# CONSTRUCTABILITY PANEL

WITH HIGHWAY CONTRACTOR  
REPRESENTATIVES

# INTENT OF SESSION

- Skewed Bridge Deck Construction Joints

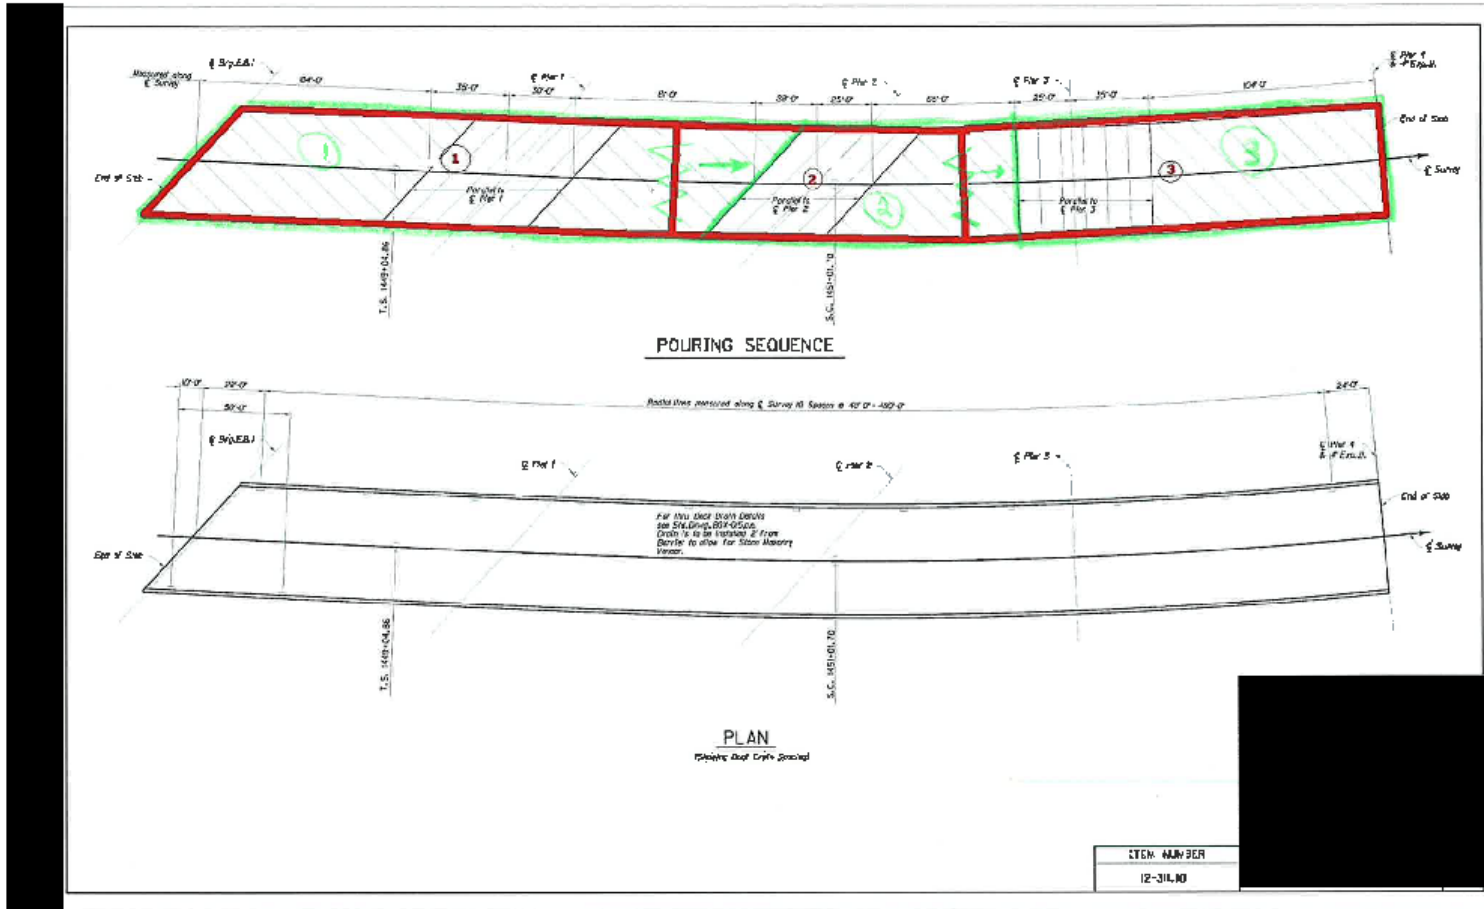
- Constructability issues
  - Hard to form, brace and finish
- Potential solutions/alternatives to improve constructability
  - Place joints square to centerline

- Part width construction

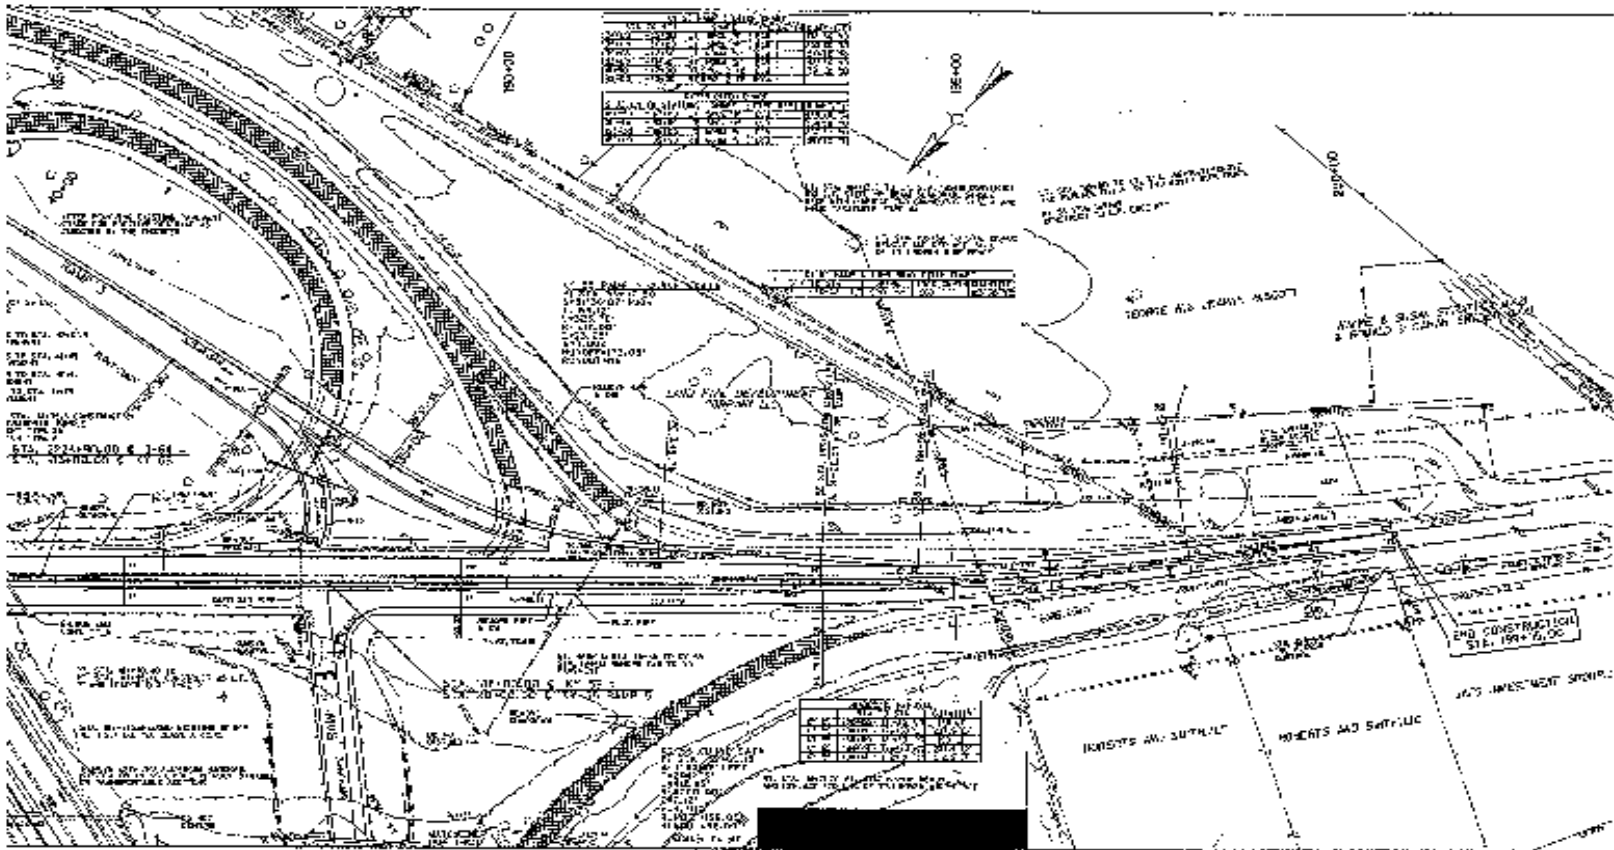
- Constructability issues
  - Plans call for part width construction on SB from 197+00 - 195+95, restricted to 7pm-5am
  - Pavement design calls for one course asphalt drainage blanket and three courses asphalt base
  - Impossible to construct in a 10 hour shift
- Potential solutions/alternatives to improve constructability
  - Construct temporary diversion
  - Utilize part width construction without time restrictions
  - Temporary road closure with offsite detour

**SECTION ON C**  
Single 8'-0" x 3'-0" x 56'-0" R.C.B.C.  
28'-0" Inlet End and 28'-0" Outlet End  
20.0000° Rt. Skew - KY #L93 Loading - 0.25 F1 Slope  
Yielding Foundation

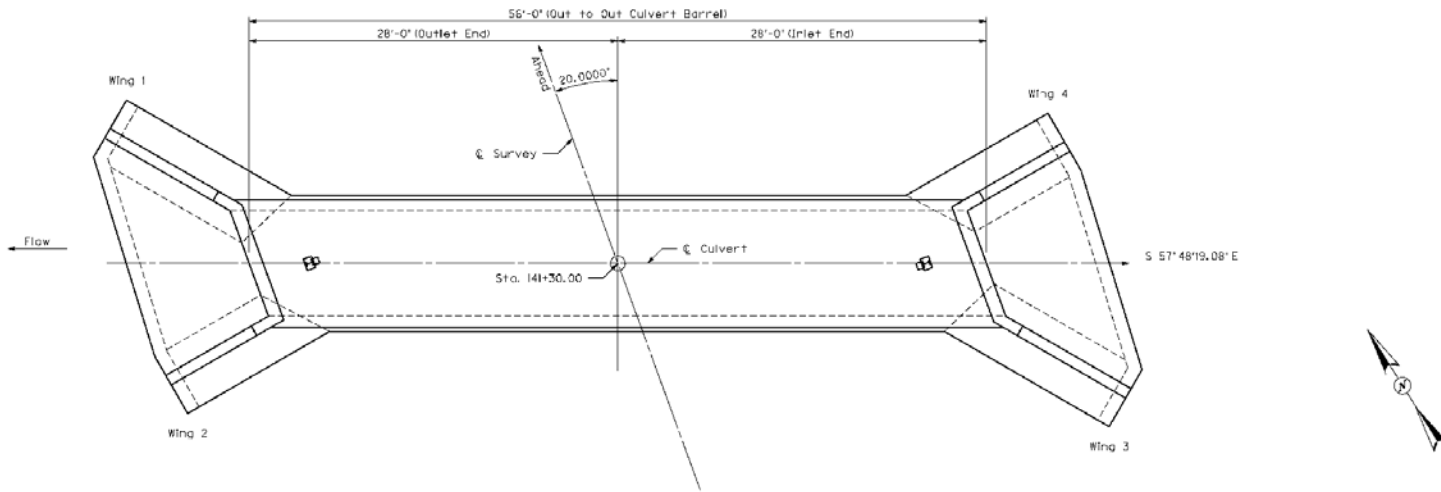
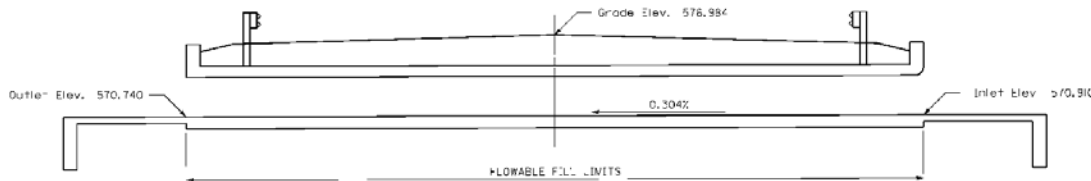
- Constructability issues
  - 9/16" X 8" Hook Bolts (RBR-015-04) must be poured in place. Each post requires four of these hook bolts.
  - It is virtually impossible for the bridge/culvert contractor to get these placed in the exact location required for proper alignment for future guard rail.

- protecting the bolts once they are in place.
    - If you place the posts upon completion of the box culvert, they are in the way of the backfill operation and will likely get damaged.

- If you backfill with the bolts exposed, they will also likely be damaged.
- Potential solutions/alternatives to improve constructability
  - Pour the deck of the culvert with no hook bolts in place.

- Allow the guard rail subcontractor to dig/auger down and expose the deck of the culvert at each location where a guard rail post is to be placed.
  - Allow the use of 7/8" Wedge Anchors, specifications and length to be determined by KYTC. Guard rail subcontractor is responsible for backfilling holes upon completing the installation of the posts on the deck.

- Geotechnical issue

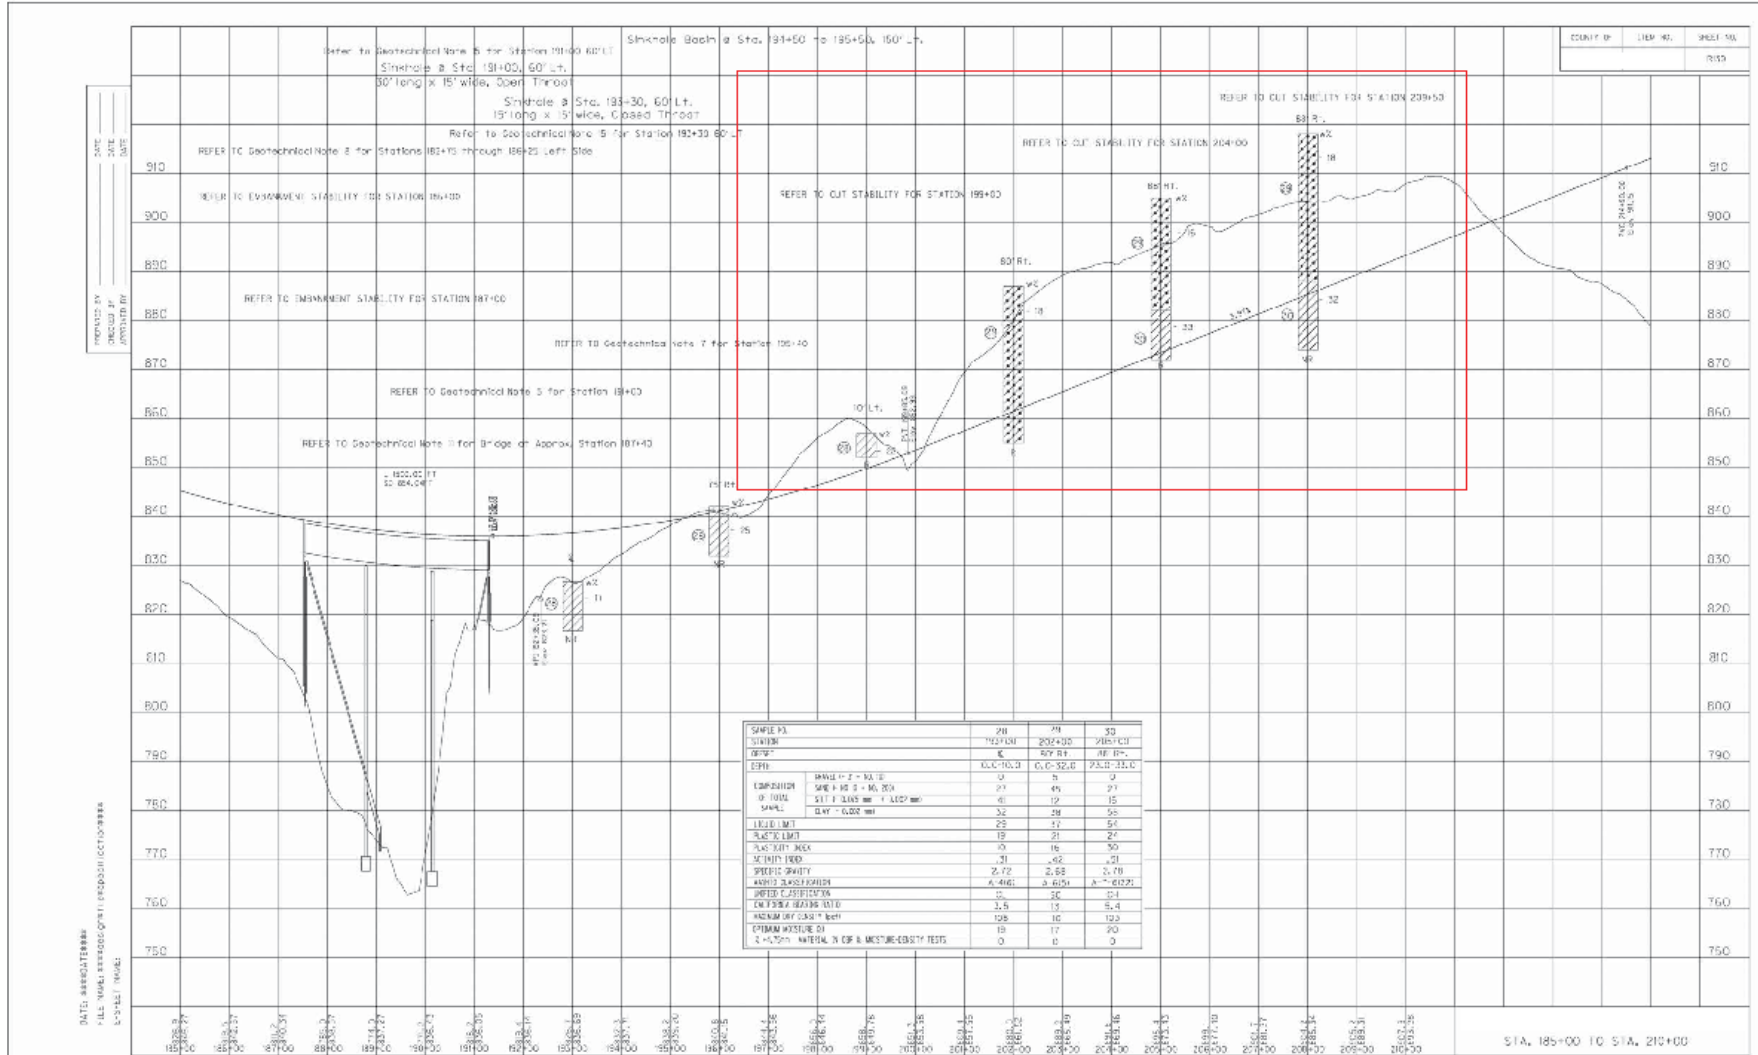
- Constructability issues
  - Unknown/unexpected geotech issues
    - Significant amount of extra work
    - Delays to project completion
- Potential solutions/alternatives to improve constructability
  - Collection of additional geotech information
  - Designs should not assume best case scenario when interpreting geotech data
  - Geotech plan notes should be written to allow parties to work together for solutions, rather than making any unknowns incidental to the contractor's bid

## TYPICAL SECTIONS -

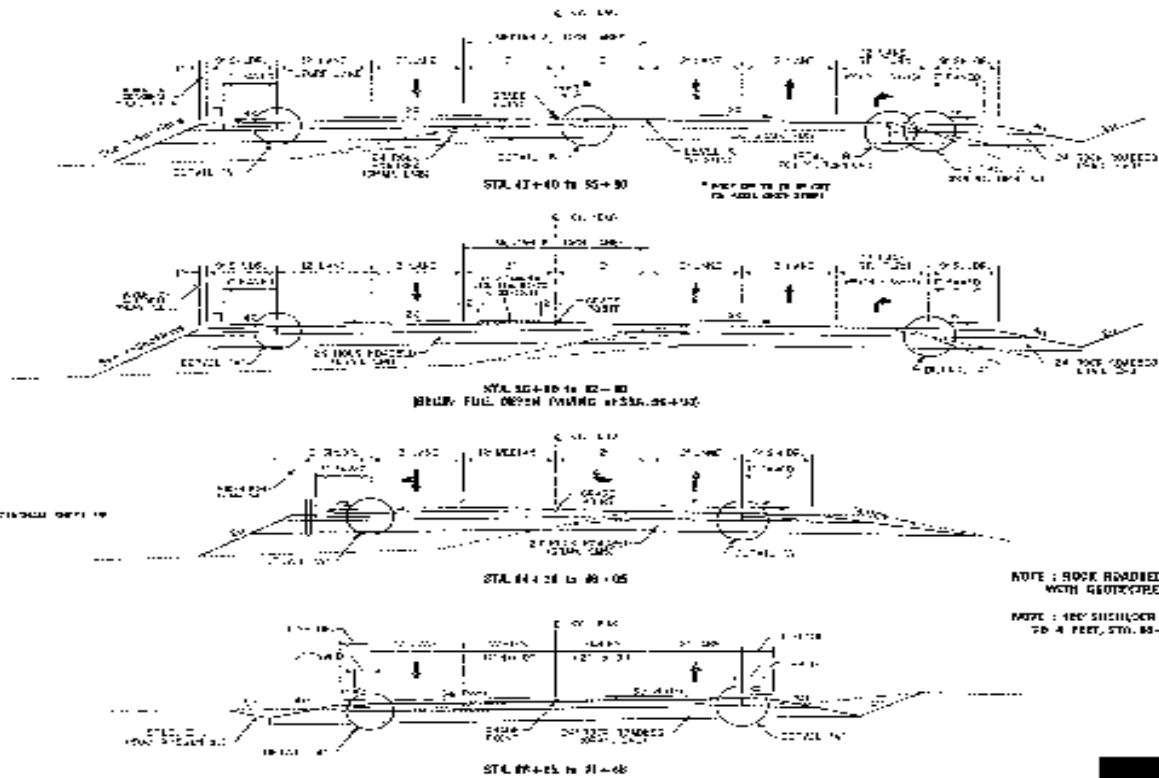
- Constructability issues
  - Plans indicate rock roadbed to be wrapped with geotextile fabric
  - KYTC personnel directed to extend DGA over fabric
  - DGA tends to slide off fabric during rain events
- Potential solutions/alternatives to improve constructability
  - Rock roadbed could be underlain and overlain with geotextile fabric, but not completely wrapped

## EXAMPLE OF WELL DESIGNED BRIDGE CONNECTION

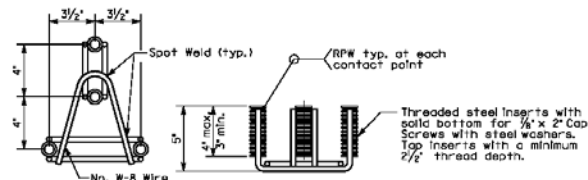
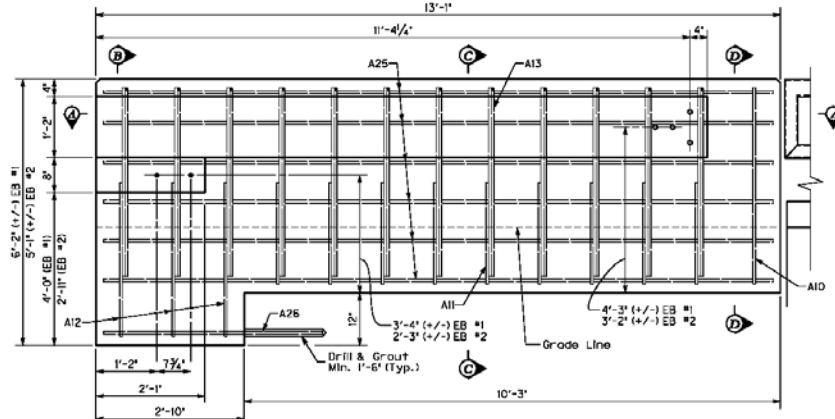
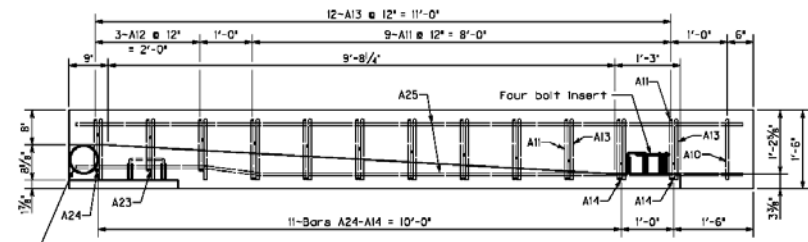
- Constructability issues
  - This bridge connector works best when connecting to Rail System Type III.
  - We now see many bridges with architectural features and wider barrier ends.
  - We have seen some barrier ends over two feet thick making it difficult to obtain the long bolts to connect the Bridge Connector Type “A” in accordance with the standard drawing.
- Potential solutions/alternatives to improve constructability
  - On barrier wall ends that are not standard (or normal), consider using a four-bolt assembly to connect the end shoe and a two-bolt assembly to connect the rub rail.

- Utility location on bridge plans

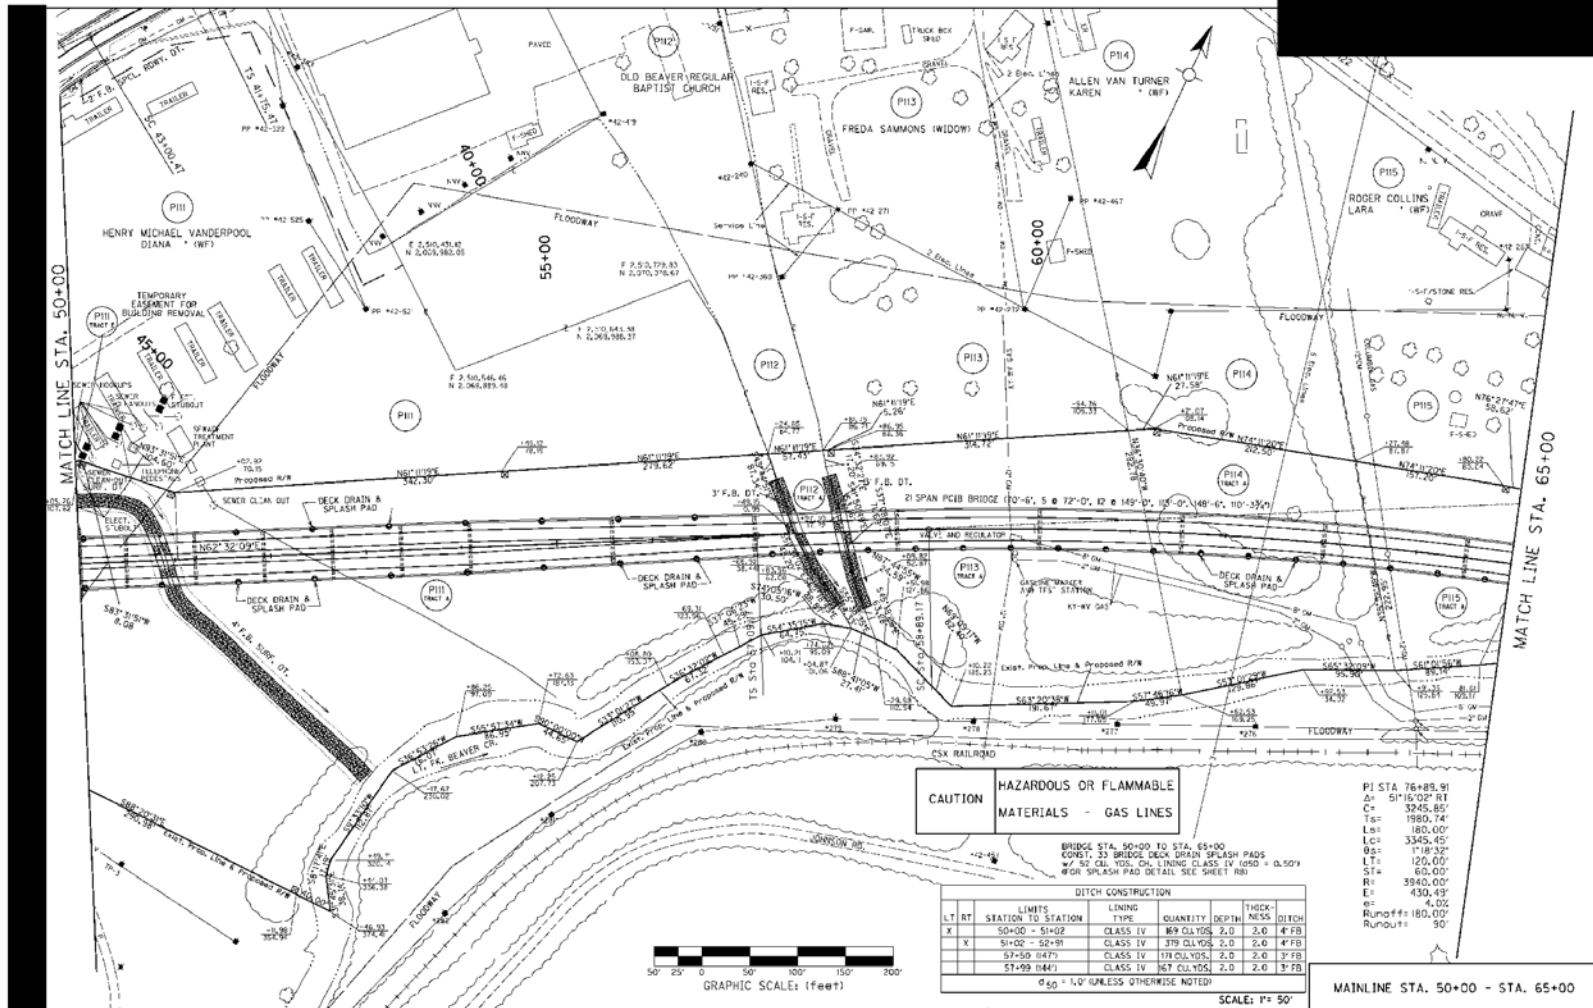
- Constructability issues
  - Just easier to see utility conflicts in bridge area with utilities shown on bridge plans.
- Potential solutions/alternatives to improve constructability
  - Put existing utilities on bridge plans
